**MEMORANDUM**

**SUBJECT:** Technical Review Comments for the Lot 46 Valley Gardens site, Des Moines, IA (22-R07-05)

**FROM:** Randall Ross, Director  
Groundwater Technical Support Center

**Figure 2:** TCE groundwater concentrations in 2021. Lines: Transects A to A' and B to B'. Scale as shown. Source: STAR 2022.

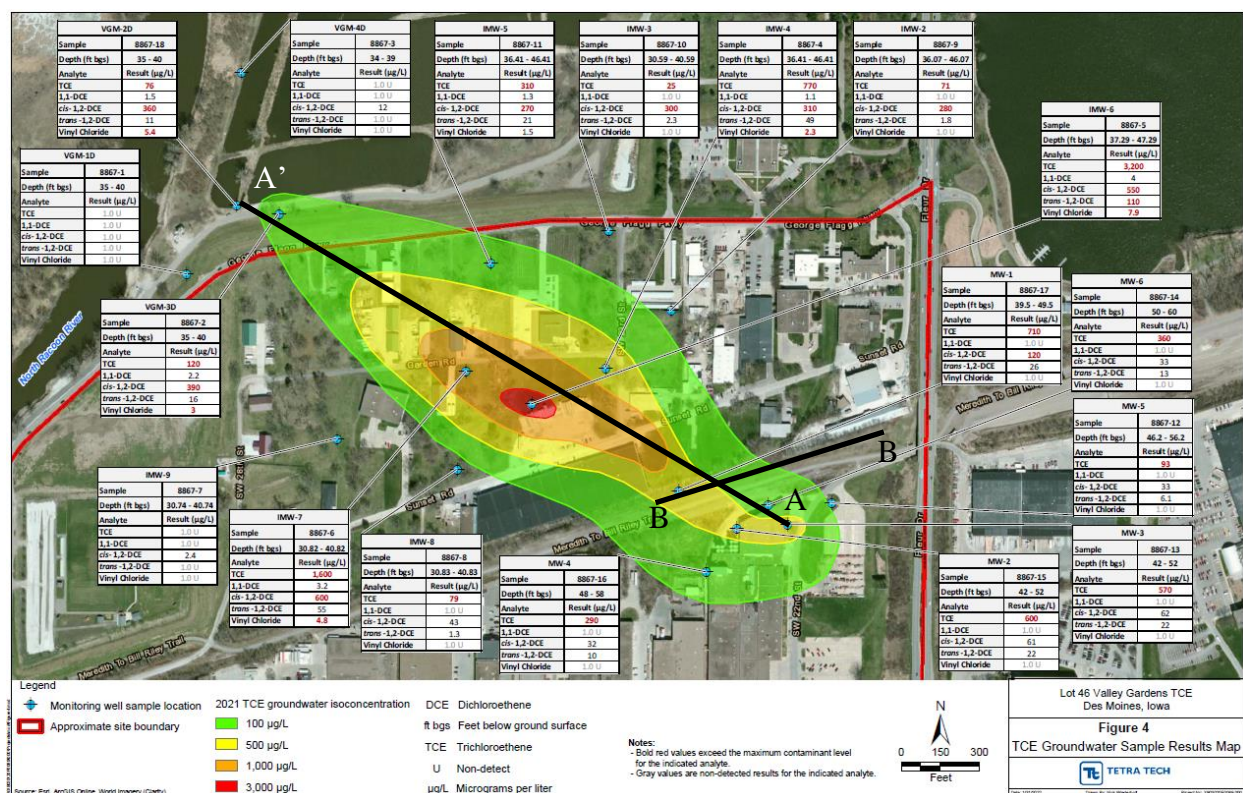
In case of the TCE plume (Fig.2), its leading edge has arrived at VGM-3D (120  $\mu\text{g/L}$  TCE) but has not resulted in detectable TCE concentration in the water collected from the Gallery. Within the plume, the highest TCE concentrations were found at IMW-6 (3,200  $\mu\text{g/L}$ ). Well IMW-6 is approximately 417 m upgradient from VGM-2D, which is abutting the infiltration lakes immediately east of the Gallery. The VGM wells are nested with the deeper ones screened within 10.7 to 12.2 m (35 and 40 ft bgs; 34 to 39 ft in case of VGM-4D) i.e., at the base of the coarse sand aquifer. The shallower VGM wells are screened around 7.0 m (23 ft bgs) (STAR 2022) i.e., the upper part of the aquifer. Apparently, the shallower VGM wells were not sampled during the 2021 campaign.

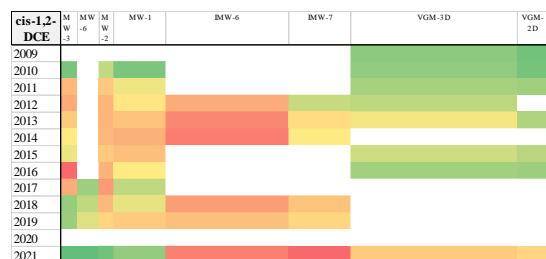
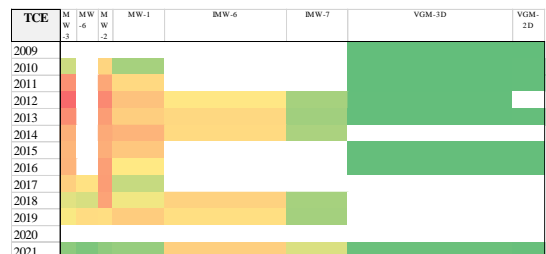
Both, Figures 4a and 4b suggests that the center of mass (= plume core) has moved (as indicated by the shift of red colors away from MW-3 over time) in the direction of groundwater flow towards the DWWW facility. This is particularly well illustrated by the 2021 data set (bottom row), which indicates that the center of mass is near IMW-7 in case of cDCE and near IMW-6 for TCE. In addition, the relatively low concentrations of the tail end of the plume (shades of green) suggest that source of contamination might be losing strength. At the leading edge of the plume, the center of mass of the cDCE plume appears to advance faster than the TCE one. Overall, this analysis agrees with the plume delineation shown in Fig. 2 and 3.

**Figure 5(a)** (Left): highest annual reported TCE concentration (µg/L) over time, **(b)** highest annual reported cDCE concentration (µg/L) over time. Red dots represent the period over which the linear trend line (red dotted line) was calculated.

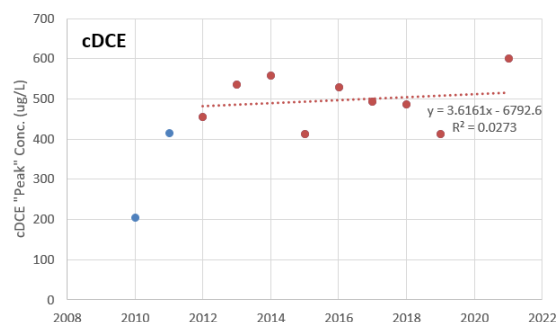
To investigate the past and future fate of the plume, the plume's center of mass i.e., the highest reported contaminant concentration for each year (see bold highlights in Figs. 4a and 4b) was plotted against distance (i.e., to the well location at which the concentration was observed; see Table 1 for distances between well locations). The resulting graphs for cDCE and TCE are shown in Figures 5a and 5b. Based on these data, a linear trend line for the period of 2012 to 2021 was calculated for each pollutant. The year 2012 was chosen because it coincides with some of the highest recorded contaminant concentrations (i.e., in the years prior to 2012 CVOC

concentrations were still rising before peaking in and around 2012). The trend lines suggest that TCE annual peak concentrations have been declining over time. For cDCE, the trend line is approximately flat or even slightly increasing, suggesting that cDCE concentrations are not declining over the observation period. If the historical trend data predict the future concentrations in the center of mass and assuming that it will take approximately 12 years for the center of mass to arrive at the Gallery, the approximate TCE concentration would be at or below detection limit at that time (~2033). The uncertainty in the future fate of cDCE is high because its concentration is linked to the currently unknown rate by which TCE degrades. Therefore, no estimate for the cDCE arrival concentration at the Gallery is provided.

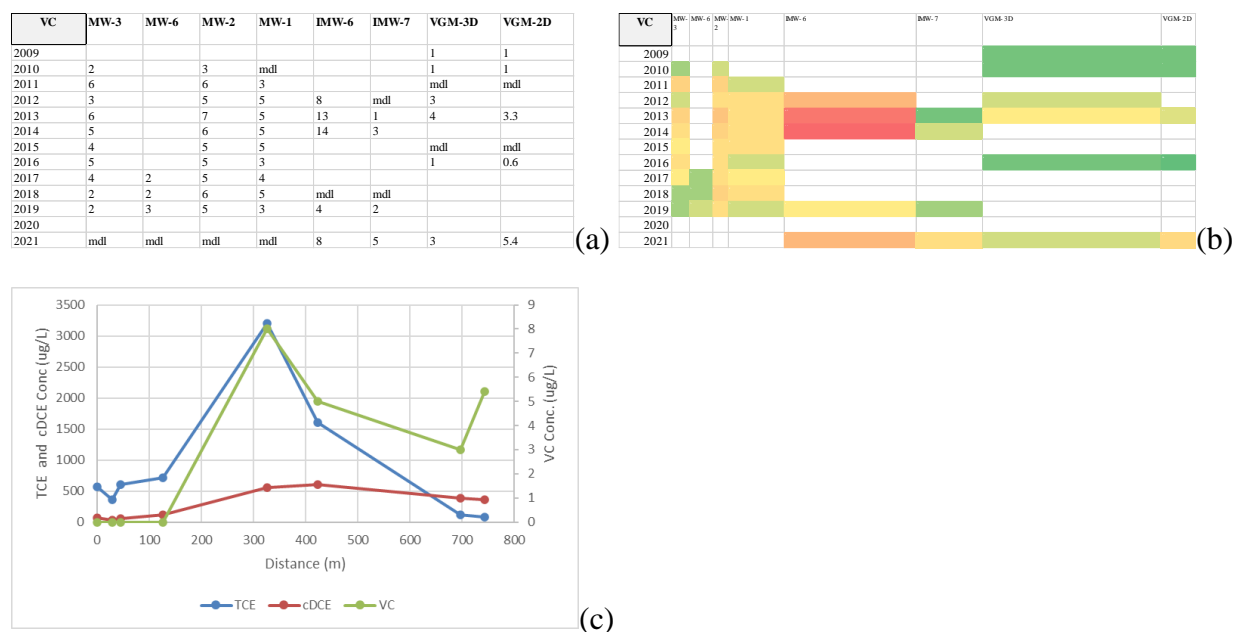
From Figures 6a and 6b, the spatial and temporal distribution of the VC concentrations along the transect resembles that of cDCE (Fig. 4a) more closely than TCE (Fig. 4b), as expected by virtue of VC being the cDCE degradation product. The highest reported VC concentration was  $14 \mu\text{g/L}$  and was measured at well IMW-6 in 2014 (Fig. 6c). Most recently, in 2021, the VC peak concentration was  $8 \mu\text{g/L}$  and was measured still at or around IMW-6. The VC peak coincided with the TCE peak in 2021 (Figure 6c) and seemingly trails behind the cDCE peak (located at or around IMW-7). This suggests that the VC travel velocity is slower than cDCE and/or it is being generated at a rate slower than cDCE being produced from TCE dehalogenation, as expected. The concentration at the leading edge of the VC plume (at VGM-2D) was  $5.4 \mu\text{g/L}$  in 2021, which exceeds the MCL for VC ( $2 \mu\text{g/L}$ ). For comparison, the method detection limit was  $<1.0 \mu\text{g/L}$  during the 2021 analysis. Overall, the data indicates that a plume of VC contaminated groundwater has formed and is moving downgradient. The absolute VC concentrations have declined from their peak in 2014 but still exceeded the contaminant's MCL by 4 times in the center of plume in 2021 and about 2.6 times at the plume leading edge. However, more VC field data would be needed to predict the future fate of this compound.

**Figure 7:** TCE degrades to DCE which degrades to VC. The data of the peak annual concentrations observed anywhere in the plume along transect A to A' indicate an enrichment in the degradation products over time.

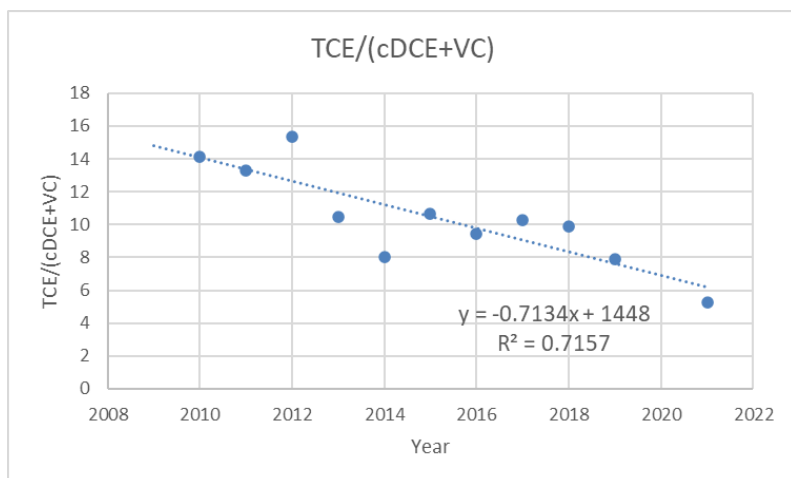
Finally, as TCE degrades to DCE which degrades to VC, one should expect a relative accumulation of the daughter products which both degrade at rates typically slower than the TCE degradation rate (Fetter et al. 2017). As Figure 7 indicates, this is indeed the case at Lot-46 i.e., an enrichment in the degradation products can be observed over time when considering the peak concentrations for each compound as observed anywhere in the plume in a given year. By approximately 2030 and assuming the historical trend holds (see trendline in Fig. 7), the sum of the degradation products should be equal or greater than the TCE concentration. From Fig. 5a, the estimated peak TCE concentration will be approximately 124 µg/L in 2030. The current data is insufficient to estimate the corresponding absolute cDCE and VC concentrations and their ratios relative to each other at that time.

**Figure 8:** Average annual cDCE concentrations at sample locations Gallery and Fleur. Data from DWWW.

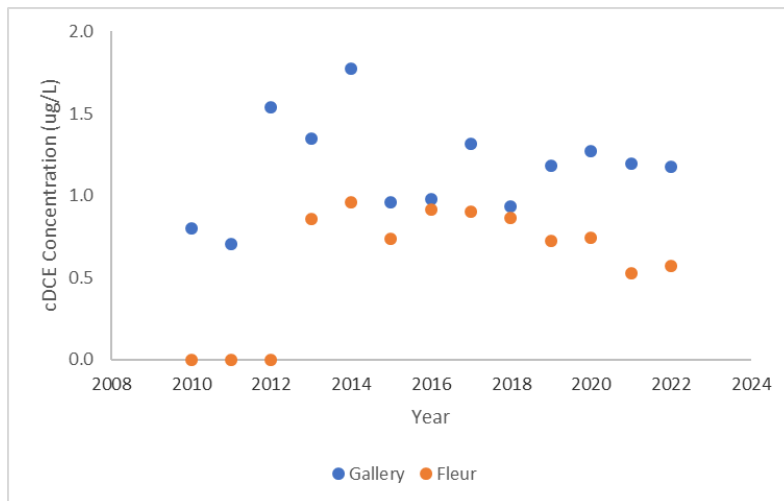
Figure 8 shows the average annual cDCE concentrations for the Gallery and Fleur sampling locations. No clear trends are recognizable at the two sampling locations. It is plausible, however, that the impact of the polluted groundwater approaching the DWWW facility has not fully manifested itself yet (i.e., the potential impact of the advancing plume may still present itself in the future). Overall, the cDCE concentration averages (as well as their maximum reported concentrations within a given year) are well below the MCL for cDCE (70 µg/L).

**Figure 9:** Groundwater concentrations of (a) TCE, (b) cDCE and (c) VC between 2009 and 2021 wells MW-1 through MW-3. These wells are considered closest to the unknown source of the TCE release.

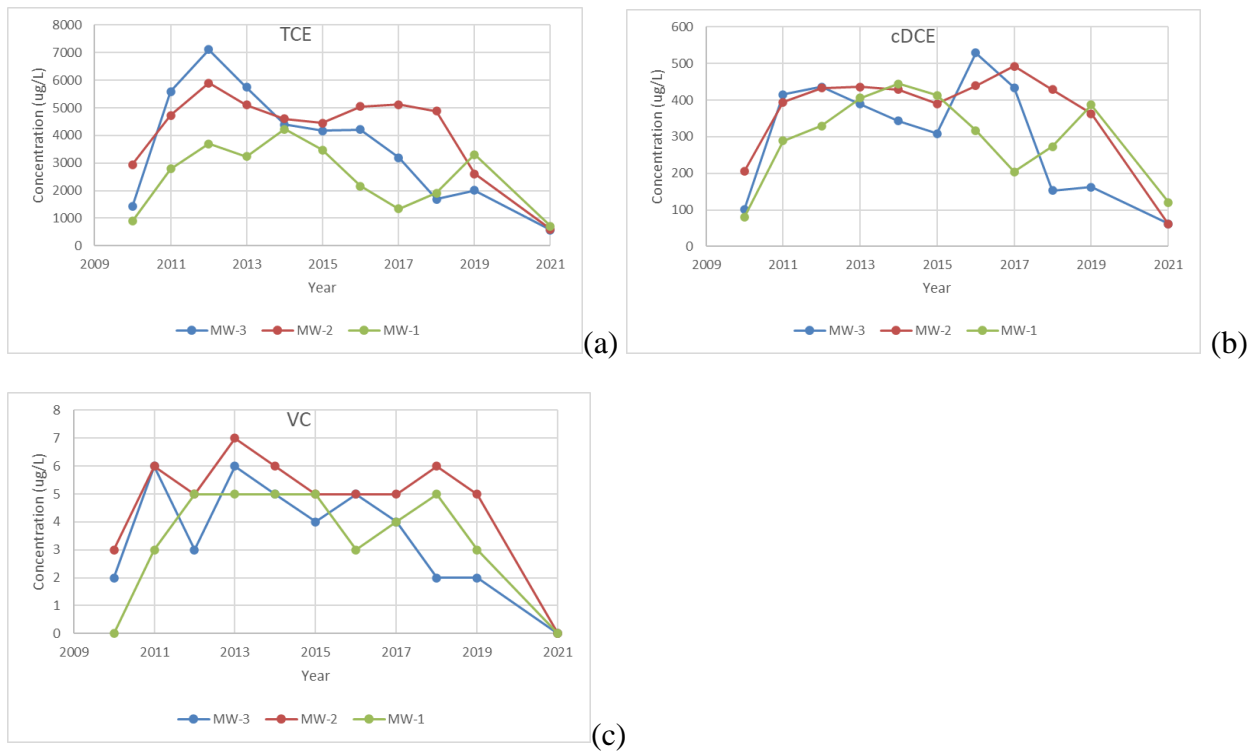
As shown in Figures 3 and 4a, the history for cDCE plume is more complex. That is, the center of mass appears to have oscillated between wells IMW-6 and MW-3 between 2010 and 2016. However, data gaps obscure the picture. Like TCE, the cDCE center of mass has traveled down gradient and left less polluted groundwater in its wake i.e., about 9 times lower concentrations at and around MW-3 compared to peaks during 2013 and 2016. From Figures 9(a) and (b), it appears that there were two TCE and cDCE peaks, respectively, at the wells located closest to the suspected source zone (MW-1 through MW-3). At MW-2 and MW-3, the first peaks occurred around 2012 and 2013 and the second one around 2016 and 2017. In case of MW-1, which is located downgradient for the other two wells, two peaks occurred about two years later i.e., around 2014 and 2019. Additionally, as for TCE, the highest initial cDCE concentrations were observed in well MW-2. Overall, the cDCE data also suggest that at least two separate spills occurred and that the source zone might have been close to MW-2 than MW-3.

The interpretation of the VC concentration data set is even more difficult than the cDCE data because the VC concentrations are fluctuating in a narrow range (Fig. 9c) and are near the method detection limit (1 ug/L). However, it appears that the highest initial VC concentrations were observed in well MW-2 and that there might be two peaks in 2013 and 2019. The delay of the VC peaks relative to cDCE should be expected by virtue of VC degrading from cDCE.

**Figure 10:** Approximate boring locations by Terracon along former railroad track. Black Line: Transect B-B'. Modified after: Terracon April 5, 2019.

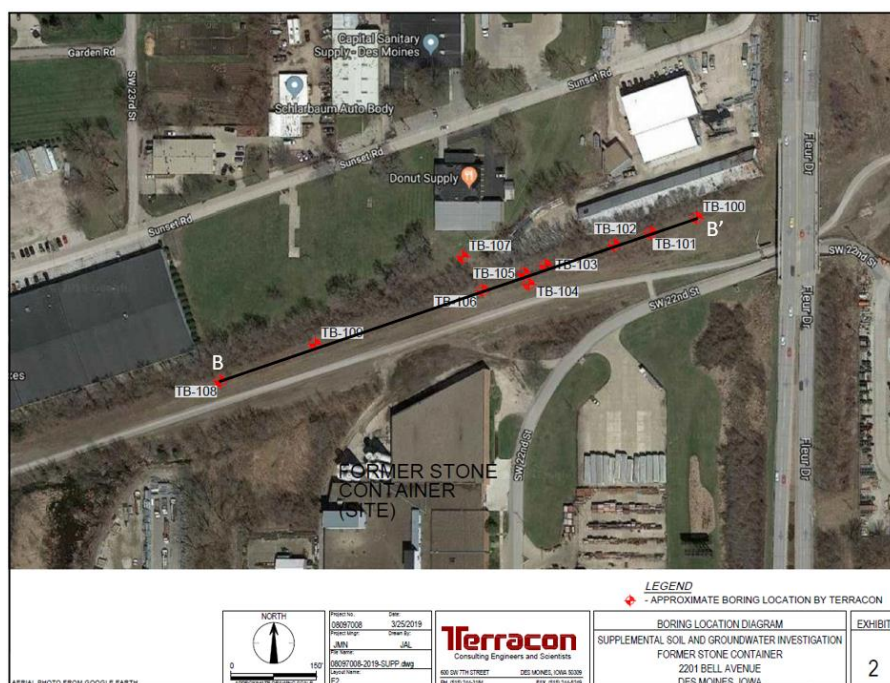
Terracon (April 5, 2019 report) measured CVOC groundwater concentrations in 10 shallow/deep wells (TB-100 S/D to TB 109 S/D) along the former railroad track separating the Packing Distribution Service from the Former Stone Container building (Figure 10). The path of the plume crosses the line of these wells (transect B-B'; Figs. 2 and 9) almost perpendicularly. The TCE and cDCE concentrations from the deeper wells (8.2 m or 27 ft) were plotted (Figure 11). Also included in this figure is the conditionally formatted concentration data set. The data show that cDCE and TCE concentrations are highest at and around wells TB-106D and TB-107D, respectively, i.e., in the middle of the transect. Further, at this location the contamination appears largely limited to the deeper section of the aquifer (8.2 m or 27 ft) i.e., shallow wells (7.0 m or 23 ft) CVOC concentrations were at or below the compound specific detection limit (data not shown). Assumed depth to bedrock varied from approximately 13.7 to 16.5 m (45 to 54 feet) across the transect.
